**ADDENDUM NO. 1
TO
BID DOCUMENTS
FOR
MACK POOL ROOF REPLACEMENT
FOR THE
CITY OF ANN ARBOR, MICHIGAN**

MACK POOL ROOF REPLACEMENT

EXTERIOR ROOF PLAN & INTERIOR WORK PLAN

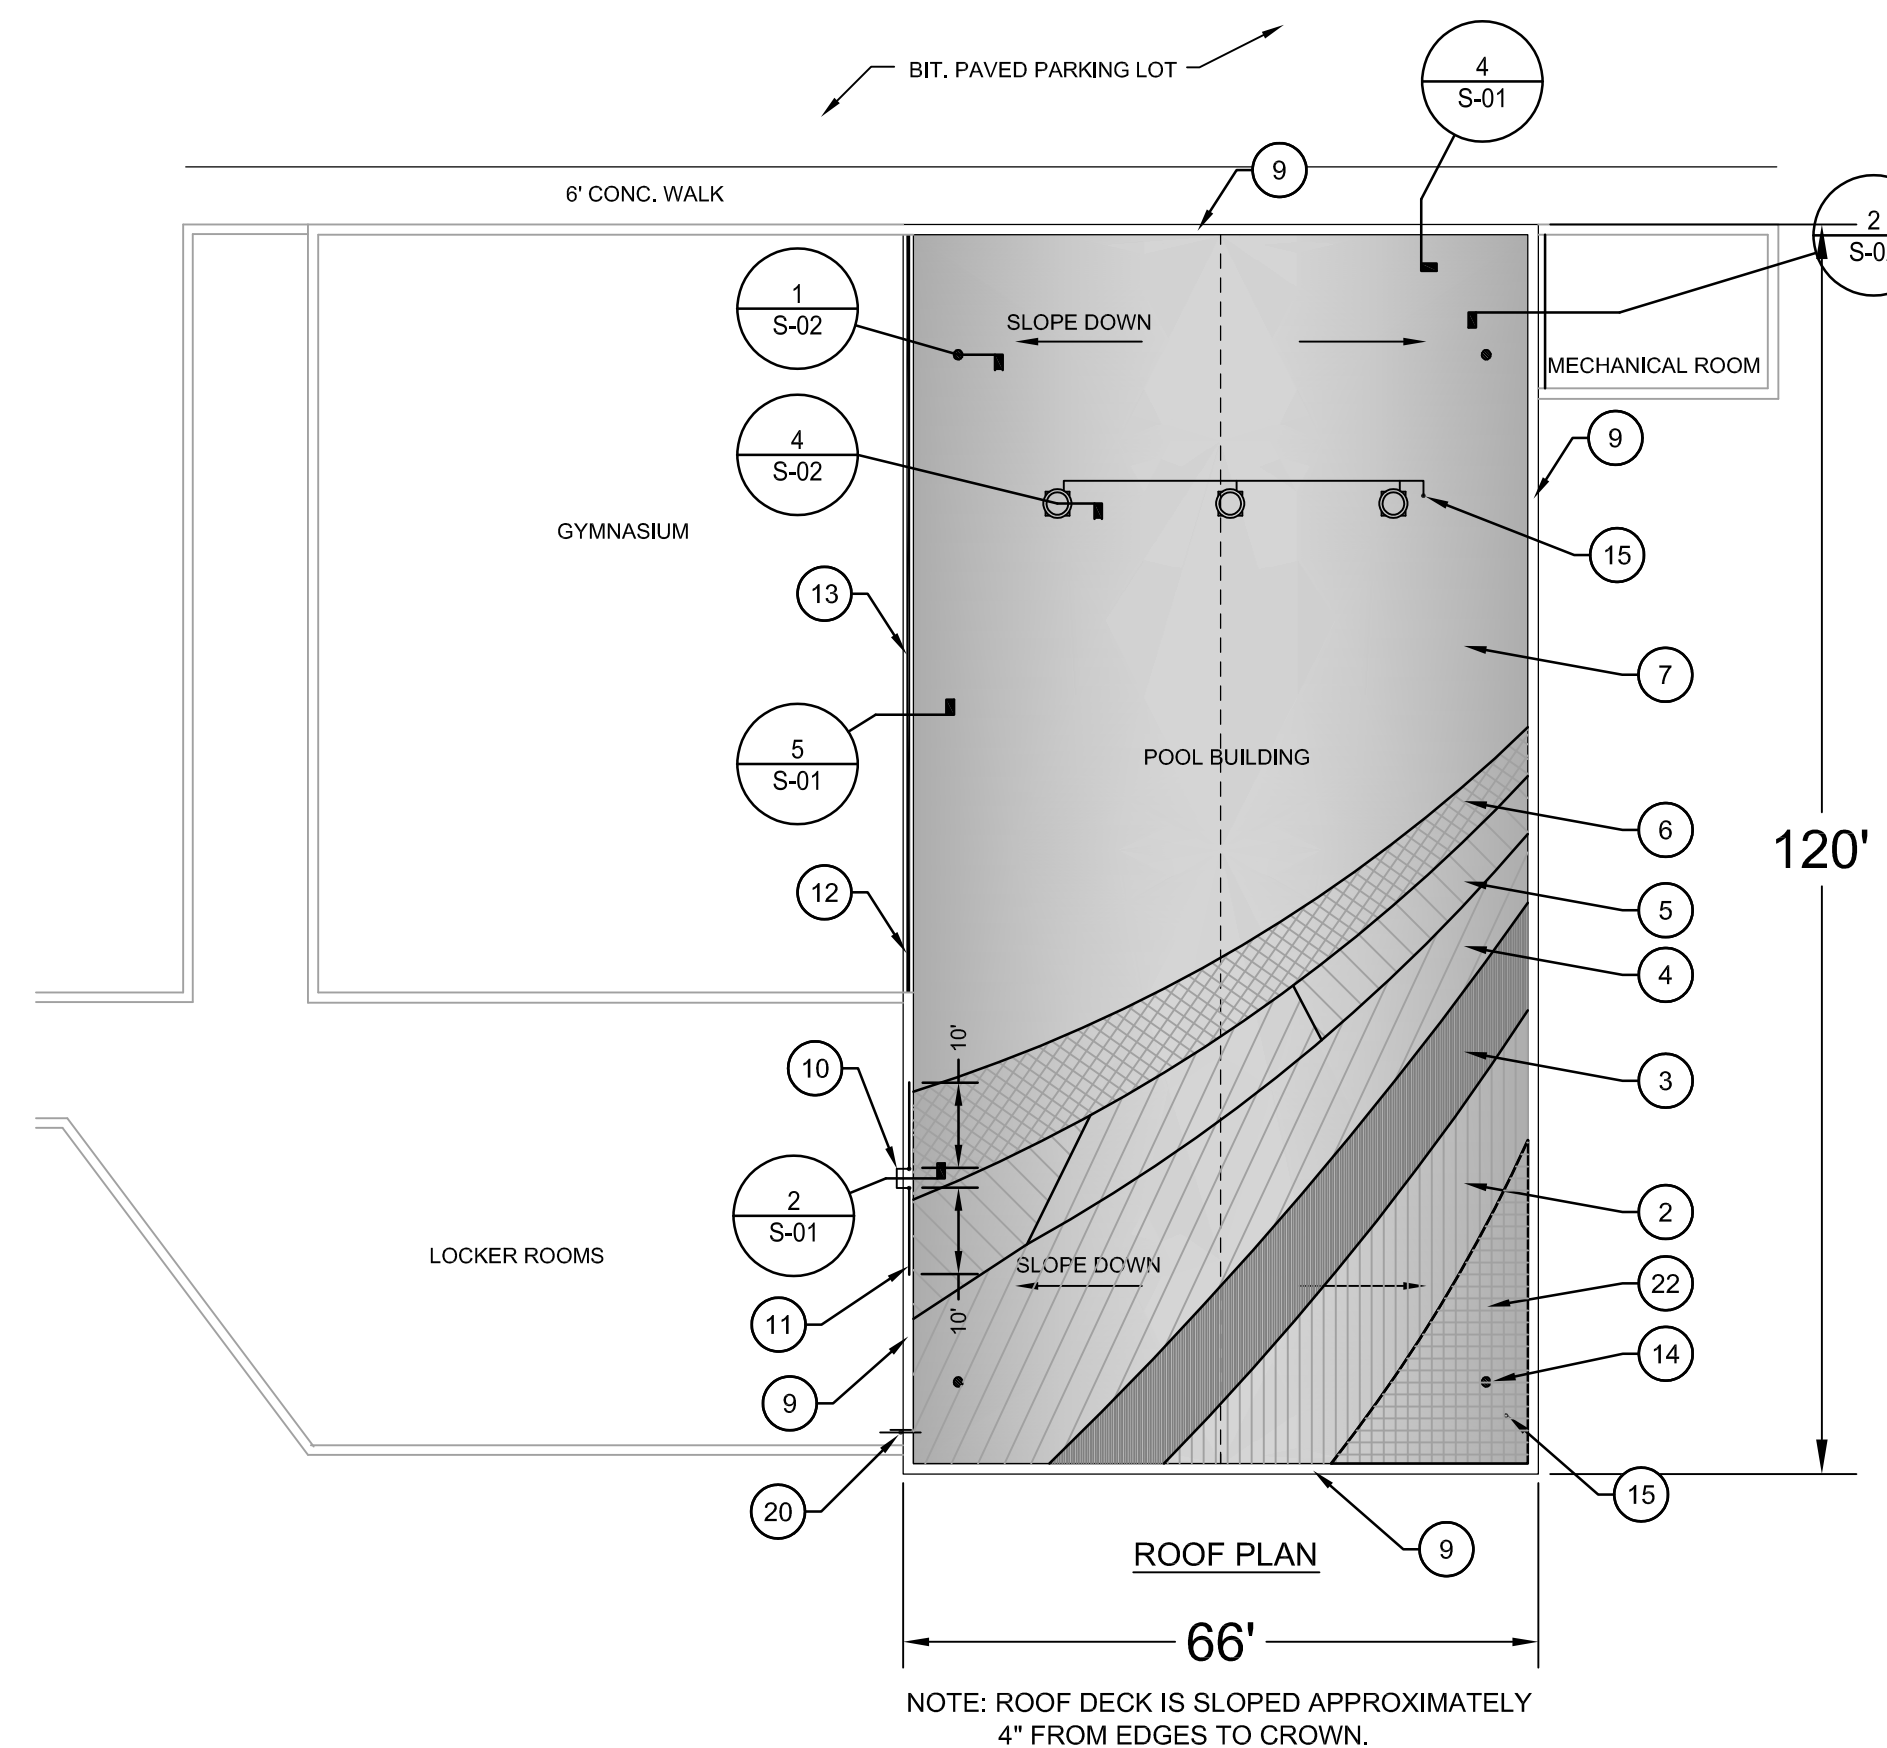
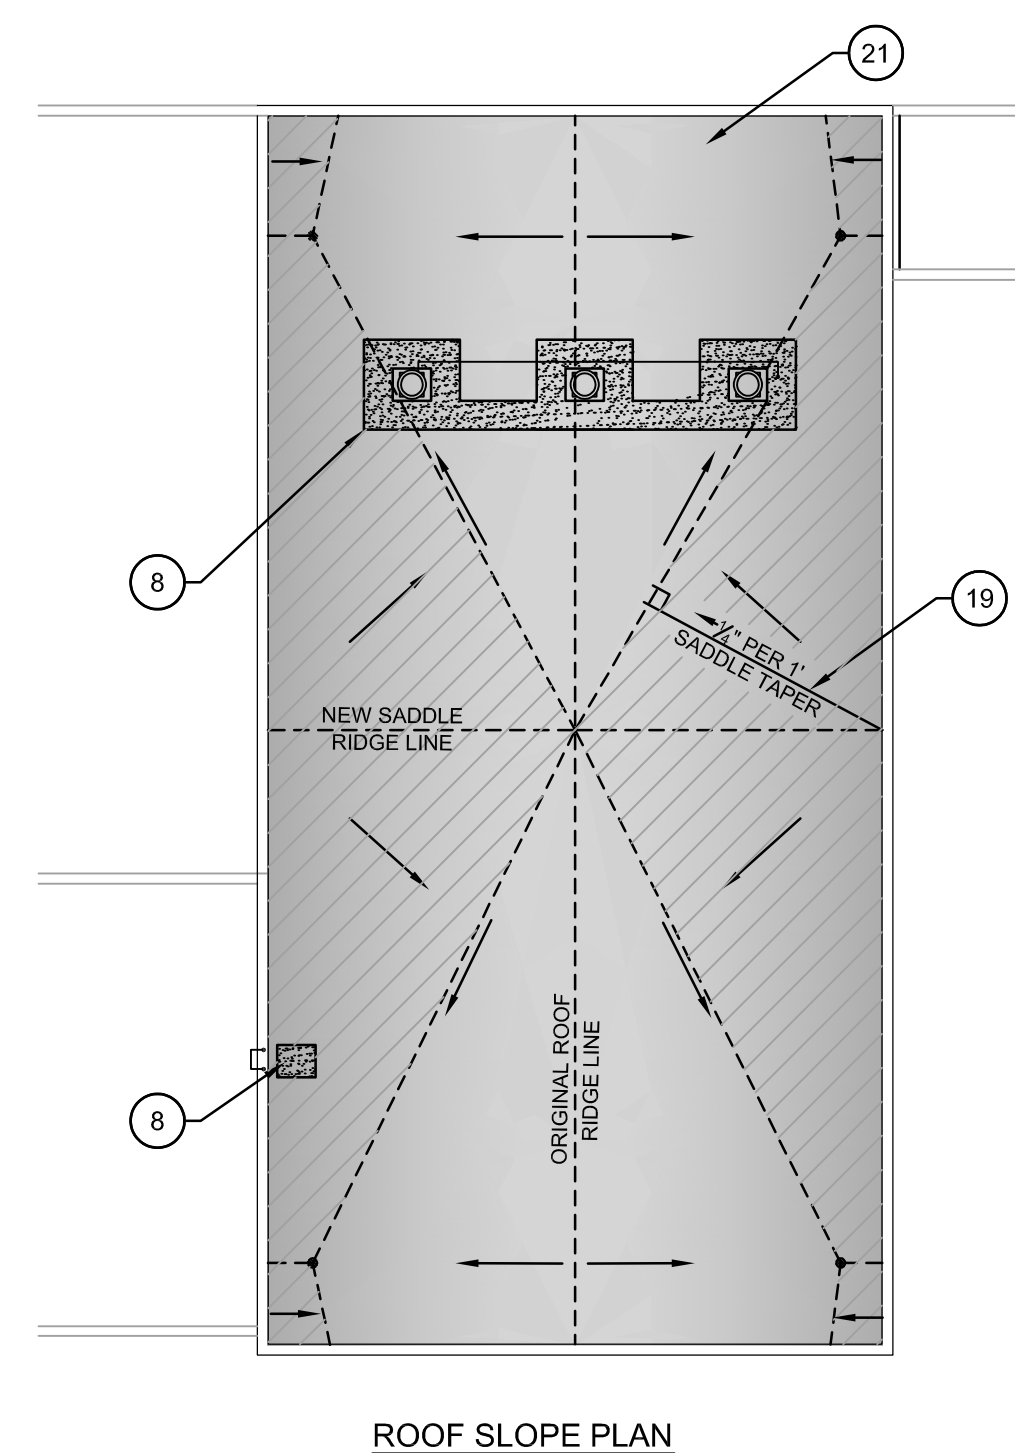
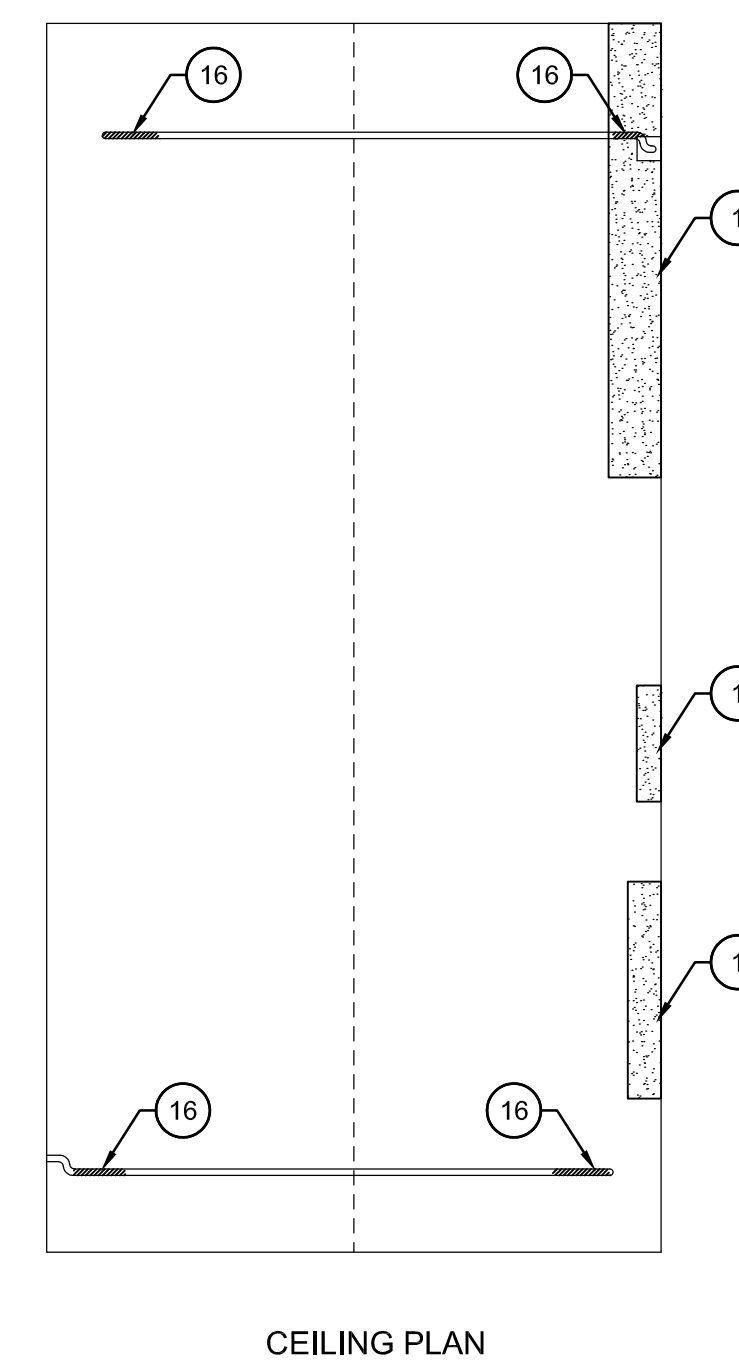
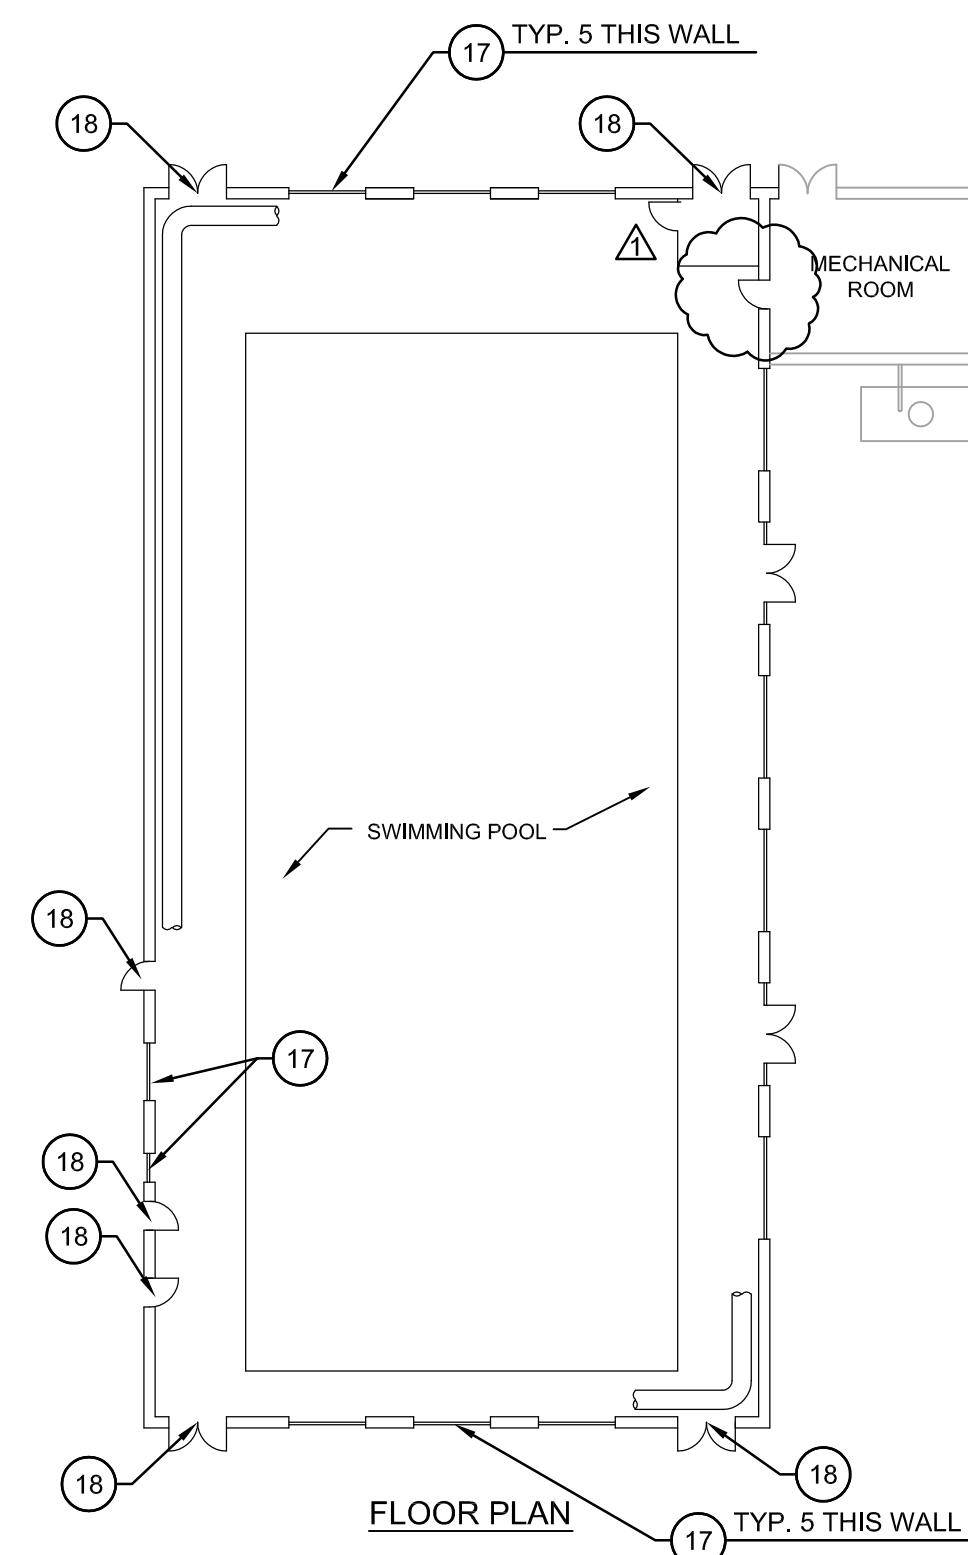
Replace drawing C-03 with the attached revised drawing. The electronic .pdf file has been saved as a 24" x 36" drawing.
